**OHIO RIVER BRIDGES
SECTION 1 - KENNEDY INTERCHANGE
VALUE ENGINEERING STUDY REPORT**

Item Number 5-118.18 & 5-118.19

**Study Date: January 28 - February 1, 2008
Report Date: February 15, 2008**

**VALUE ENGINEERING STUDY
for
Kentucky Transportation Cabinet**

VALUE ENGINEERING RECOMMENDATION # VE-25

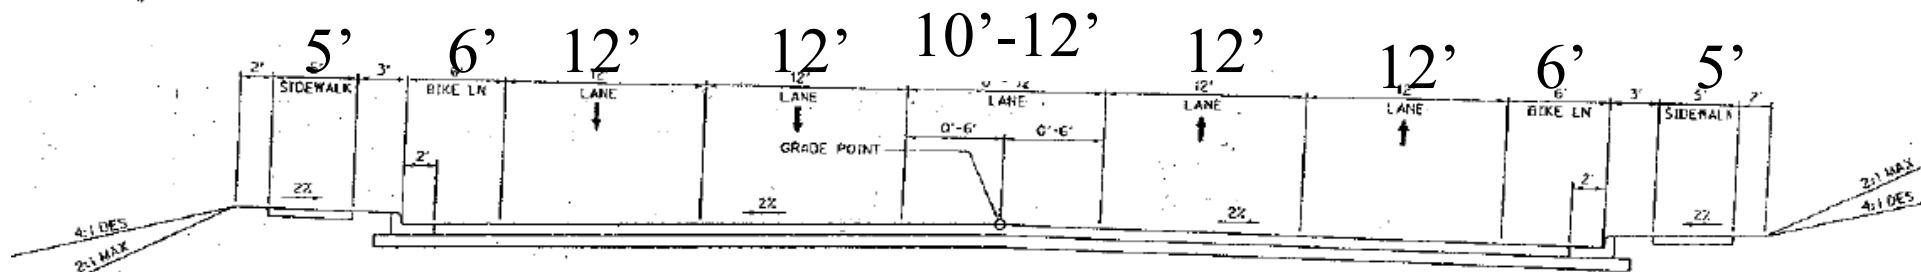
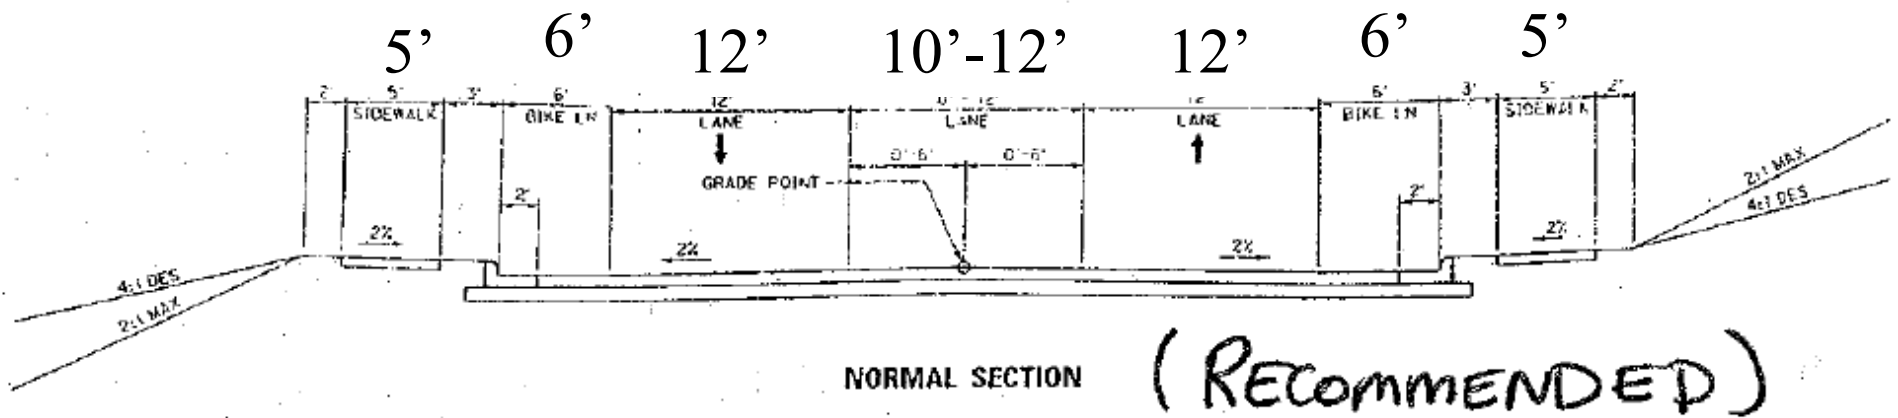
The recommended change to the typical section would eliminate one lane in each direction. The new typical section would be one-lane in each direction with a median varying from 0-12 feet. The recommended typical will include 6 feet bike lanes and 5 feet sidewalks on each side.

The reduced typical section is justified for Clay Street since the ADT is less than 2,000. This ADT was taken from a recent traffic count performed by the city. Additionally, the reduction in the pavement and bridge area reduces the initial and long term cost commitments.

VALUE ENGINEERING DESIGN COMMENT # DC-36

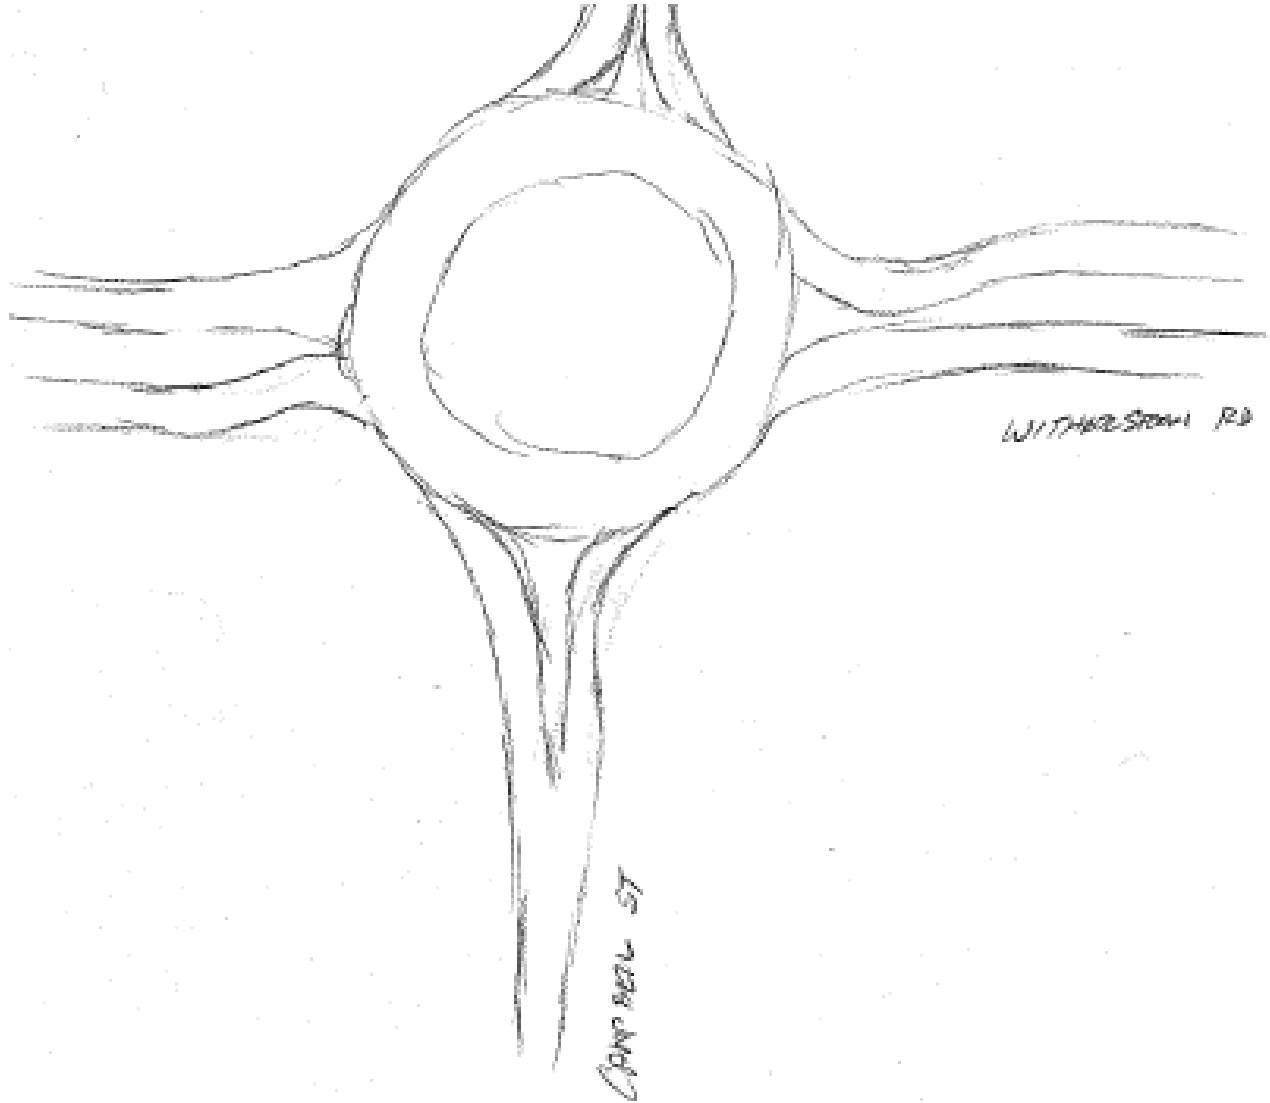
This comment recommends examining the use of roundabouts along Witherspoon Street at the intersections with River Road, Clay Street, Campbell Street, Buchanan Street, Adams Street, and Frankfort Avenue. Roundabouts provide a safe and effective method of handling traffic in moderate volume, low speed situations.

VALUE ENGINEERING DESIGN COMMENT # DC-53

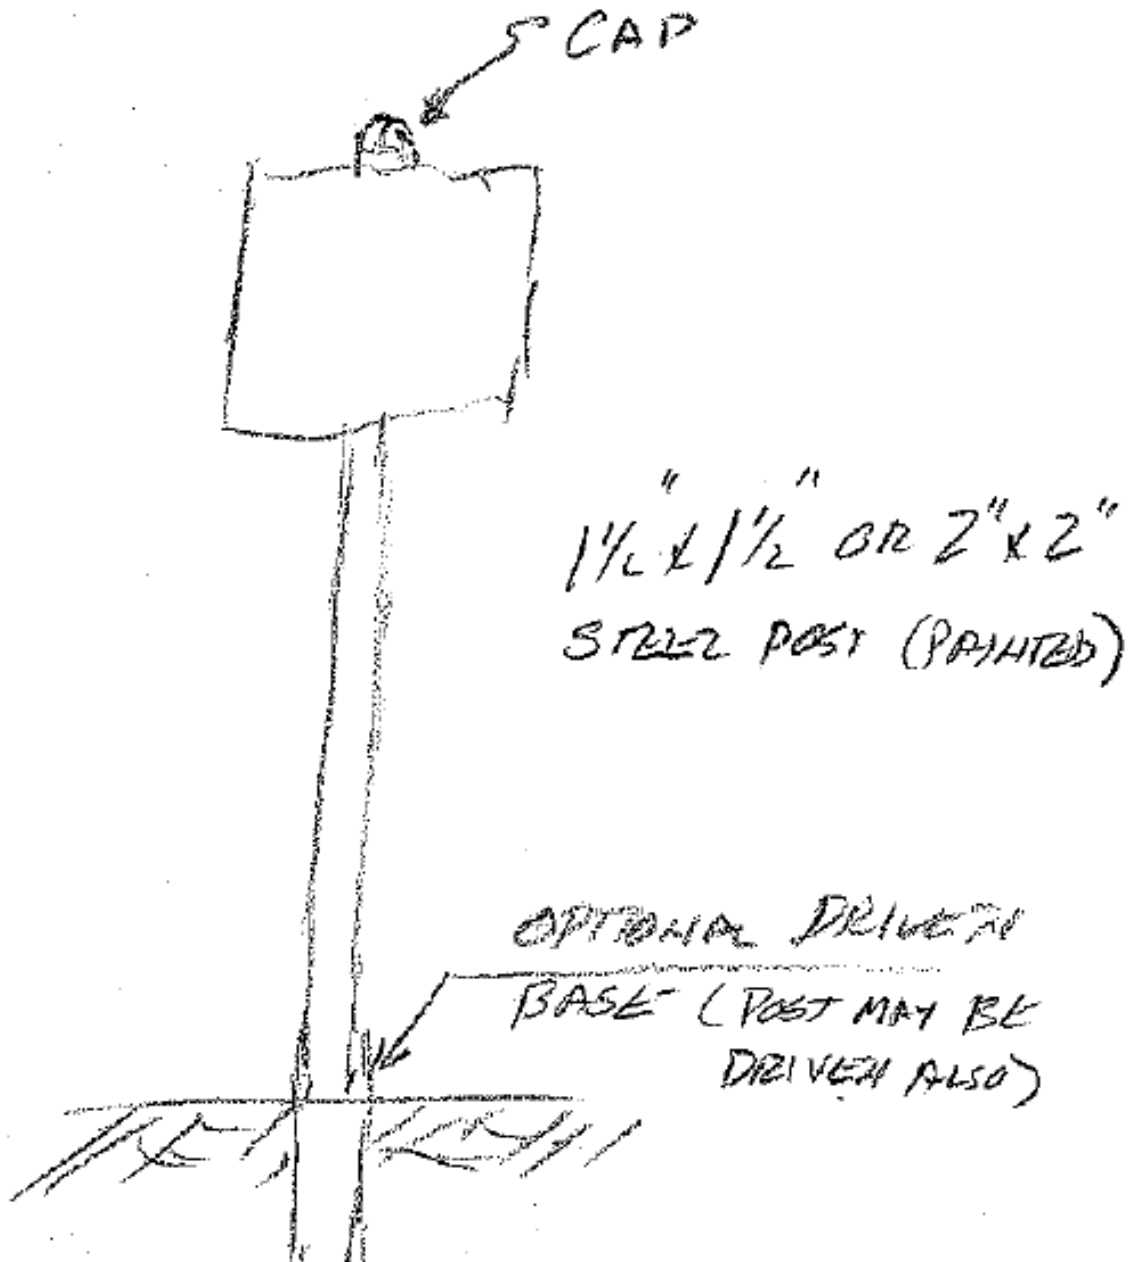
Utilize standard KYTC major guide sign support in all locations.

VALUE ENGINEERING DESIGN COMMENT # DC-59

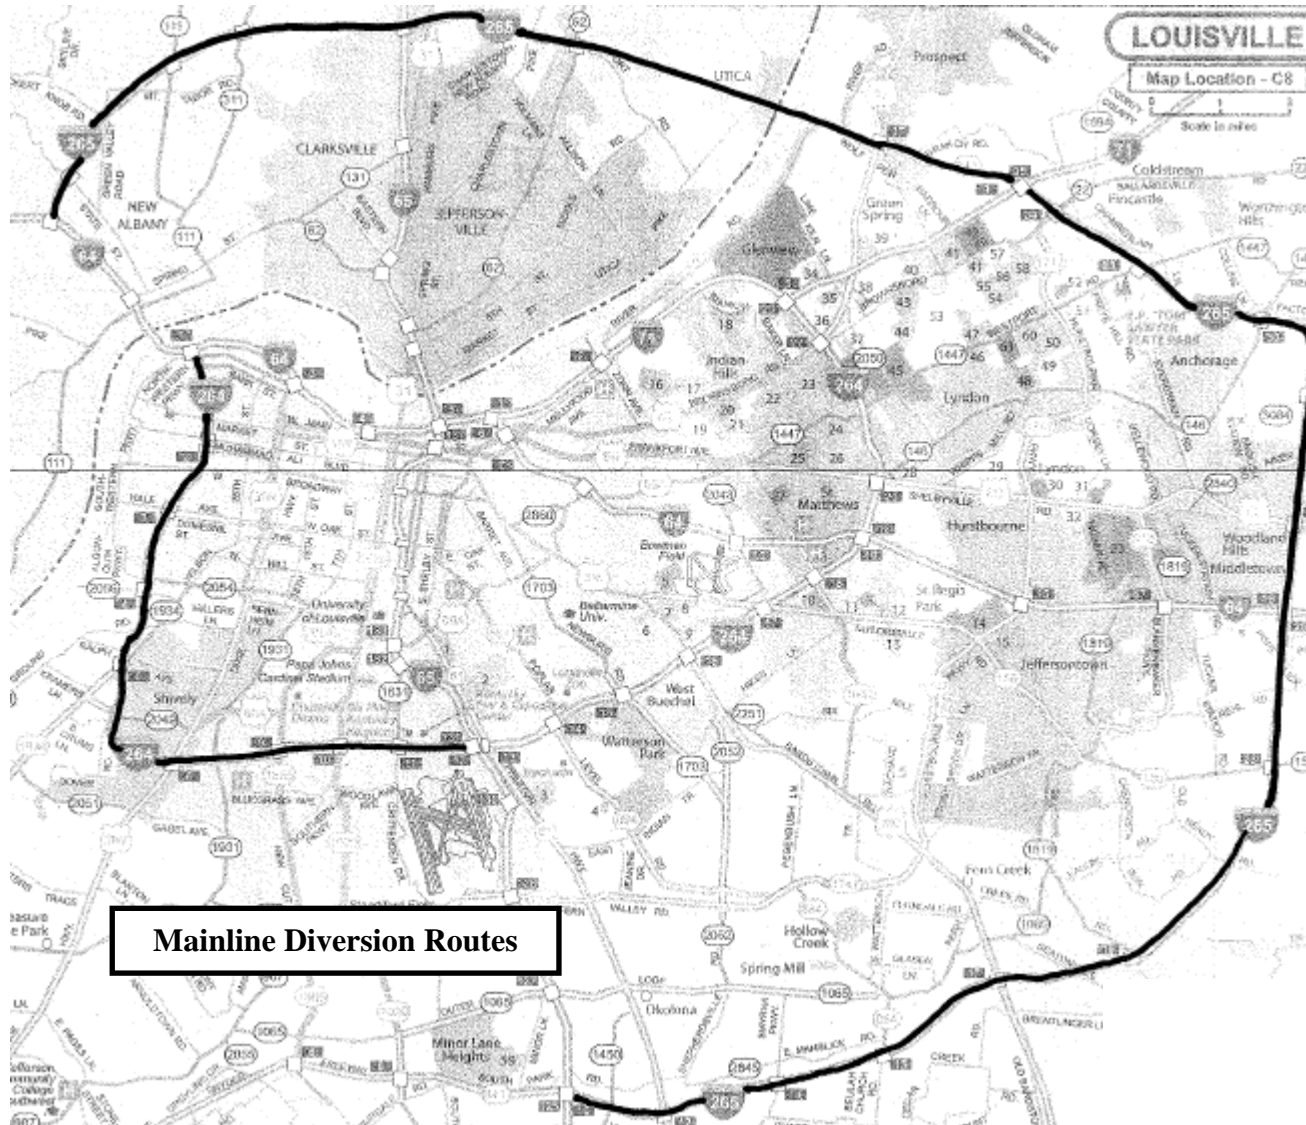
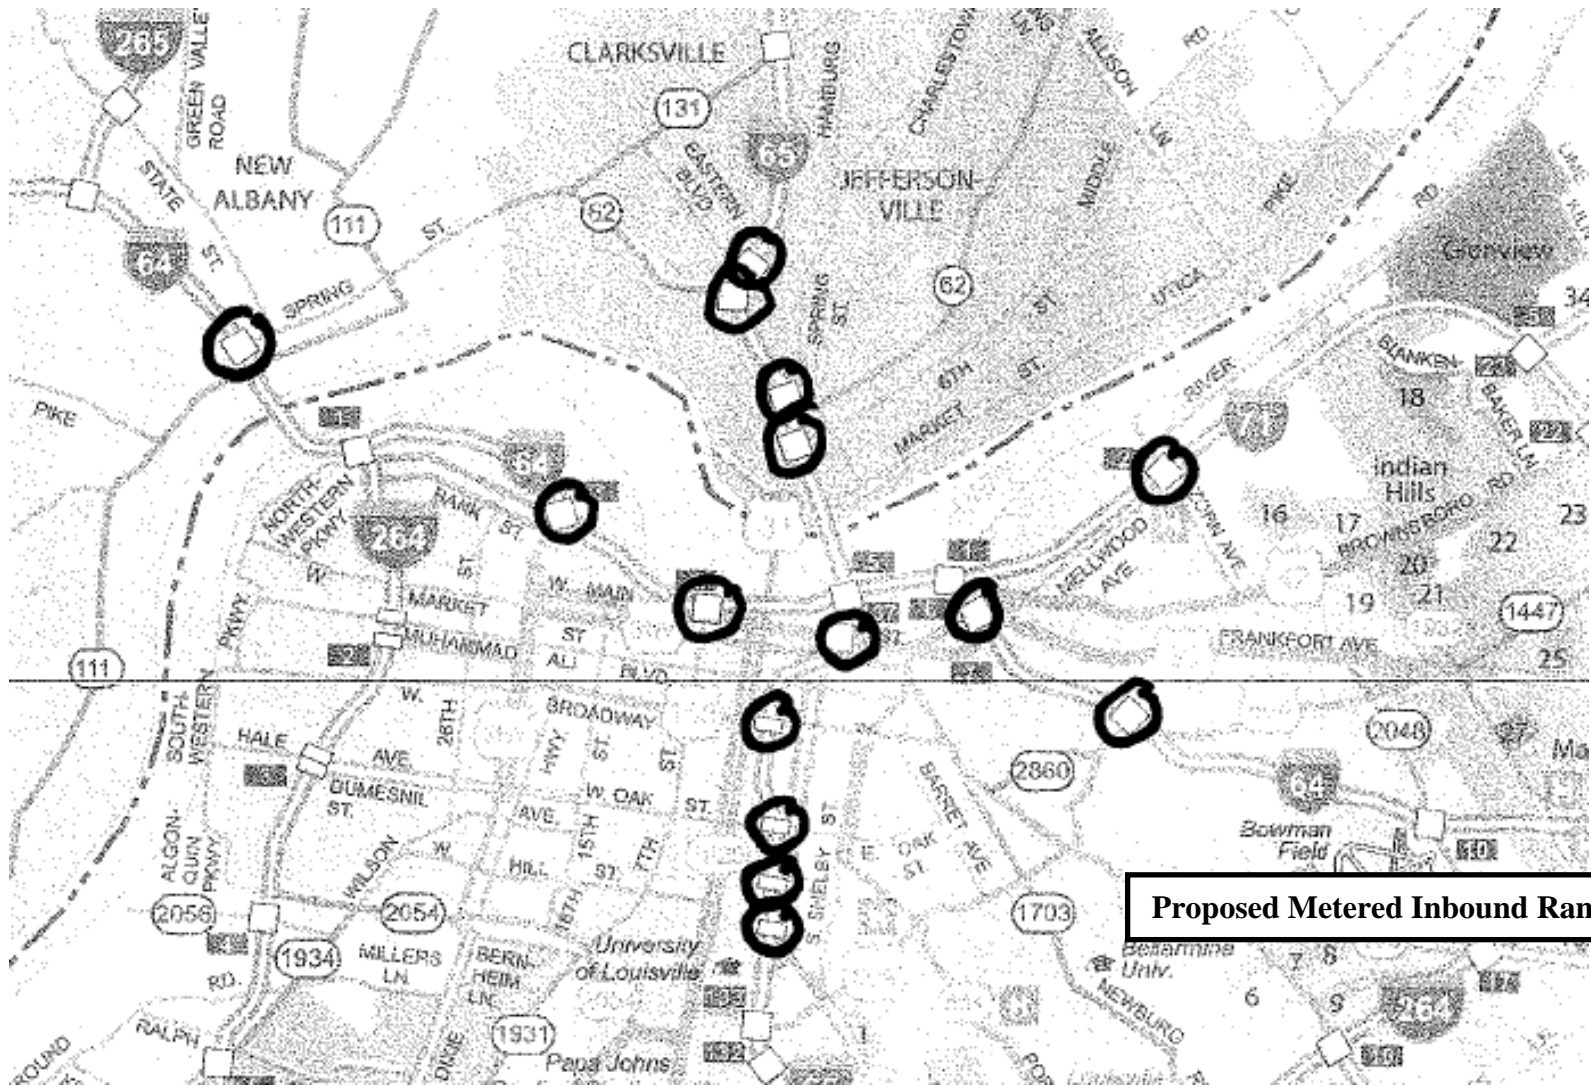
The TRIMARC freeway management system has the capability of monitoring traffic on the area freeway system. The system, in combination with temporary fixed signs, can be utilized to keep outside traffic from entering the work zone during congested conditions or during incidents.

1. Sign diversion routes on all inbound interstate approaches to the metro area (see figure 103-1)
2. Meter inbound entrance ramps during peak hours, special events and incidents (see figure 103-1)
3. Add three VMS signs at icy diversion points to supplement the existing signs on the system (see figure 103-2)

VALUE ENGINEERING DESIGN COMMENT # DC-72

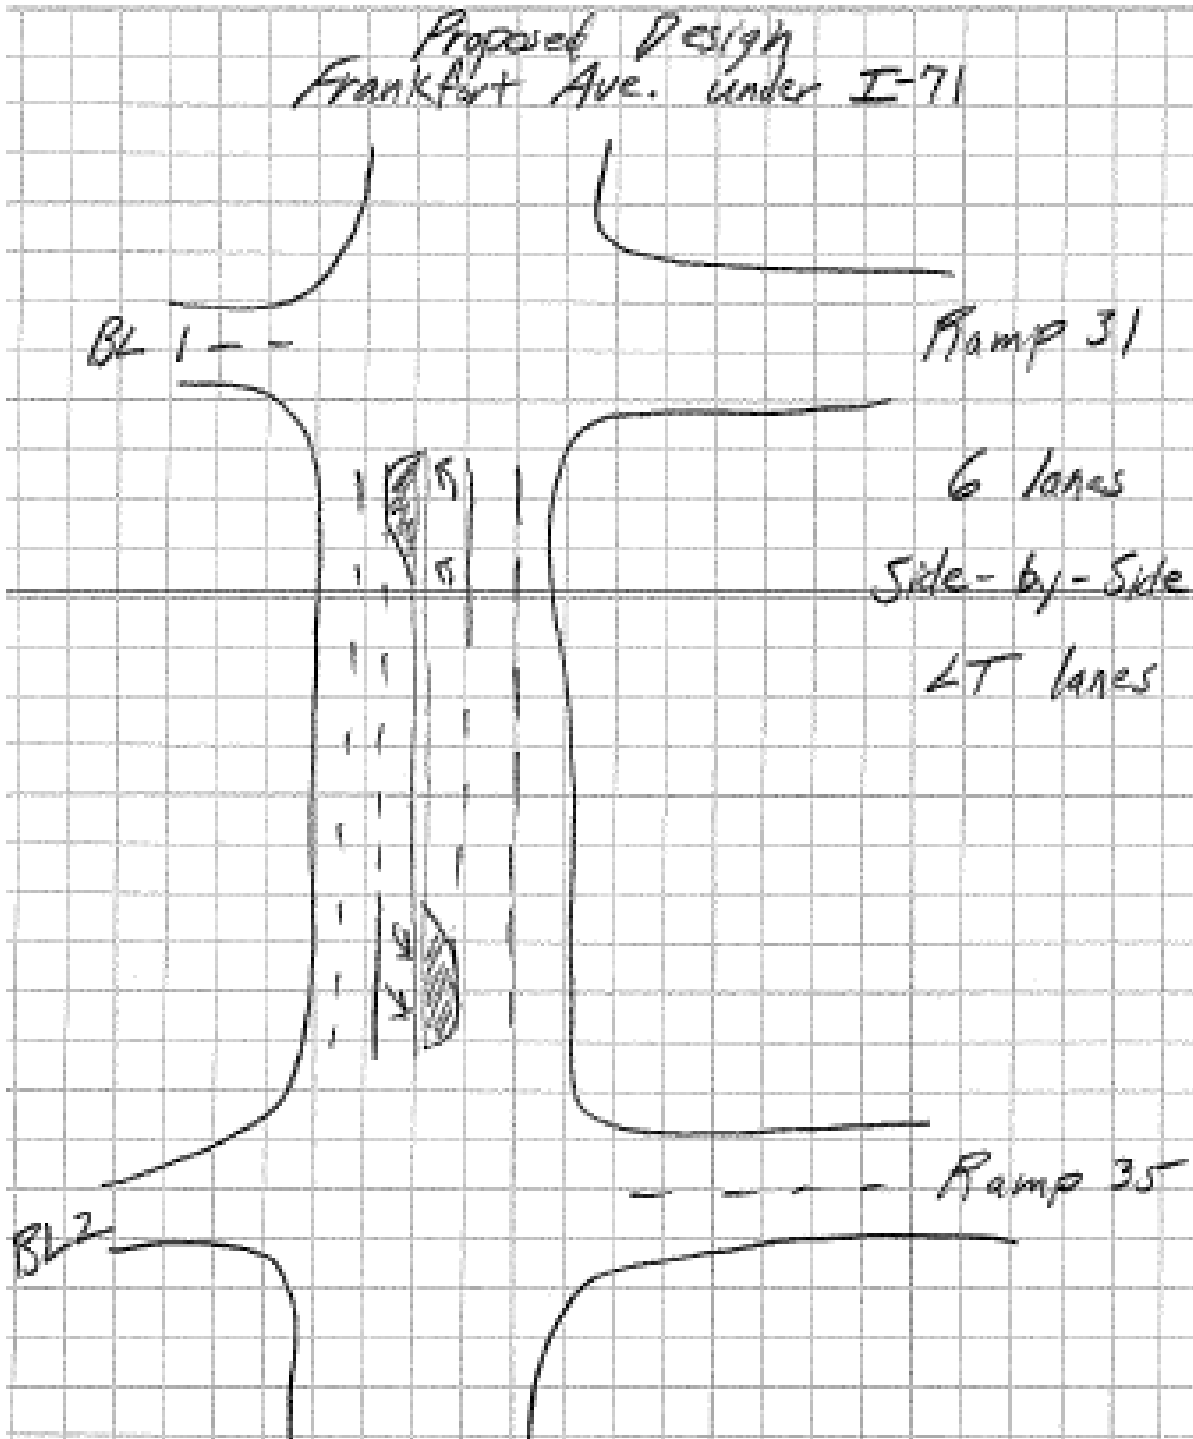
Improve the operation of the I-71 westbound and Frankfort Avenue interchange.
